ADDENDUM NO. 2
TO THE BID DOCUMENTS
Alder Ln. Water Main Extension
CITY OF HOMER, ALASKA

Addendum Issue Date: July 2, 2021

1. New Service Connections

ALDER LANE WATER MAIN EXTENSION
WATER MAIN PLAN + PROFILE
STA 14+00.00 to 19+00.00

SHEET NO.:
C-2R1

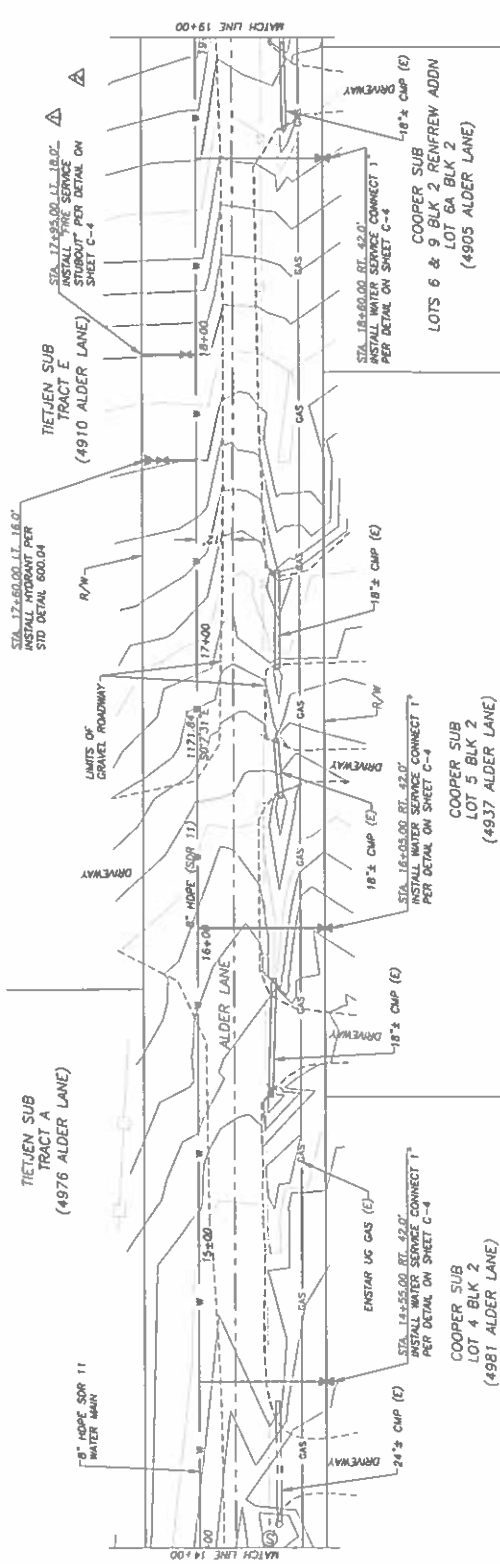
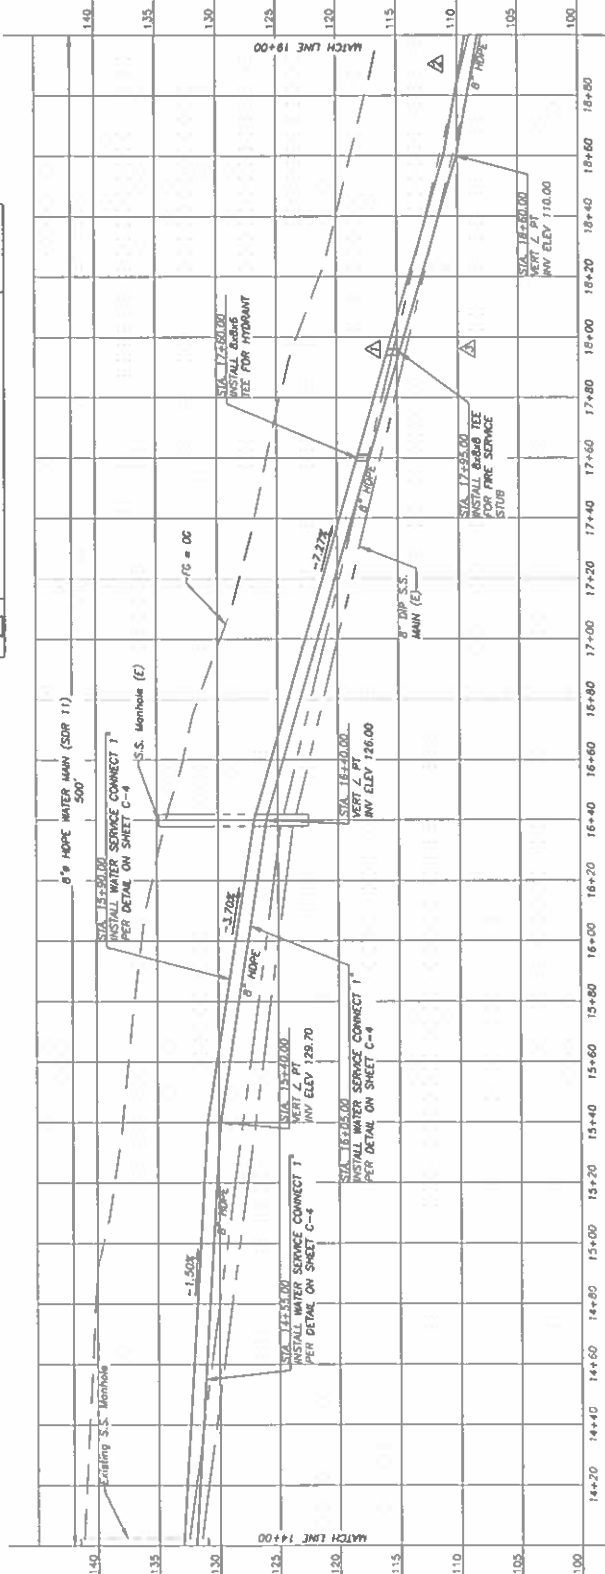
The City has made an agreement with Lexicon LLC to use their lot as a staging area as shown on the site map. In return, Lexicon LLC has requested that the City install two 8-inch service connections for their property instead of the single 1-inch service connection currently shown on the plans. Attached are new plans which show the locations of the 8-inch service connections (connections are marked as “fire service stubout”), an updated bid form which will include the materials required to construct the new service connections and a purchase order which will show a list of the required materials. All materials stated in the purchase order will be provided by the City.

Mark	Description	Date
△	Fire Stub Out added	6/21/2021
△	Fire Stub Out deleted	6/21/2021
△	Note deleted	6/21/2021

SHEET NO.:
C-3R1

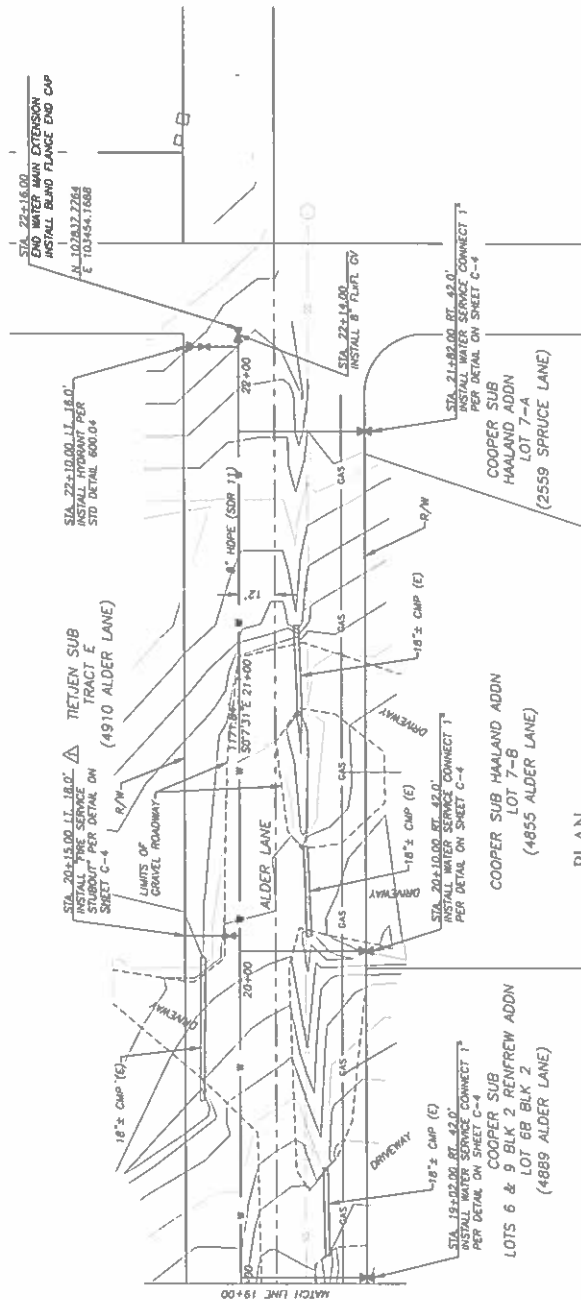
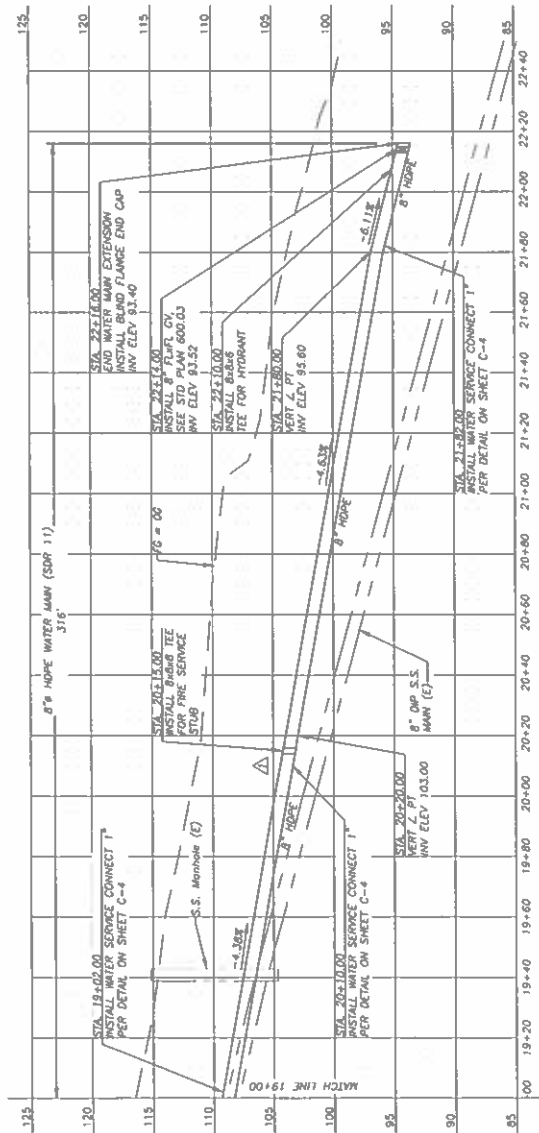
REVISIONS	
Mark	Description
A	Fire Stub Out added
	Date
	6/21/2021
